UNITED STATES PATENT AND TRADEMARK OFFICE

APPLICATION NO.	FILING DATE	FIRST NAMED INVENTOR	ATTORNEY DOCKET NO.	CONFIRMATION NO.
09/919,748	07/31/2001	Robert E. Gillis	016494-001100US	5719

Office Action Summary

DETAILED ACTION

FIG. 19

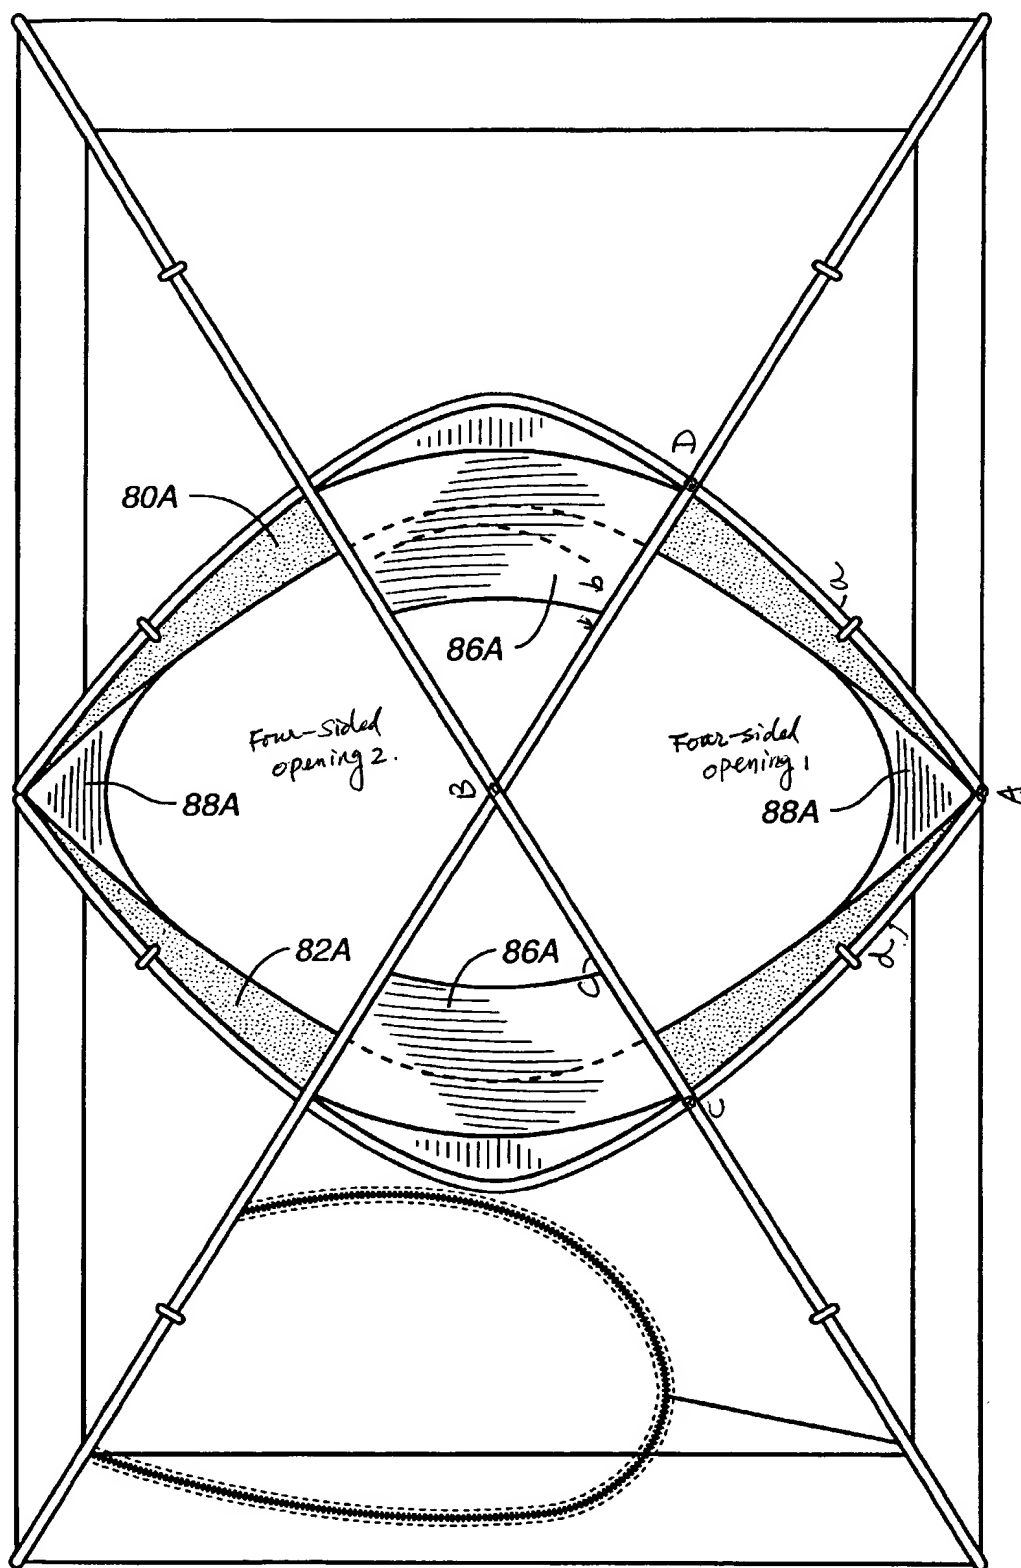
Kramer et al. show and disclose a frame for a shelter structure (see attached Figs 17, 19, and 20), comprising: a plurality of flexible poles (12) each having two terminal ends, the poles being assumed a substantially arcuate shape under tension with the two terminal ends being terminated into a common plane such as to the ground to define a dome-shaped interior volume, the poles being intersected to form a plurality of crossings such that a plurality of four-sided openings (areas 10c of Figs. 17 and 19; and areas 10D of Fig. 20) are formed by the intersected poles, each of the four-sided opening having vertices (A, B, C, D) formed by crossings of poles and sides formed by sections (a, b, c, d) of poles, a flexible membrane being connected to the poles at a plurality of points. Wherein, in Fig. 16, Kramer et al. further teach the frame includes at least one tension harness (84) connected between the diagonal vertices of the opening, the tension harness also having free ends being fastened to the ends of the poles on the common plane.
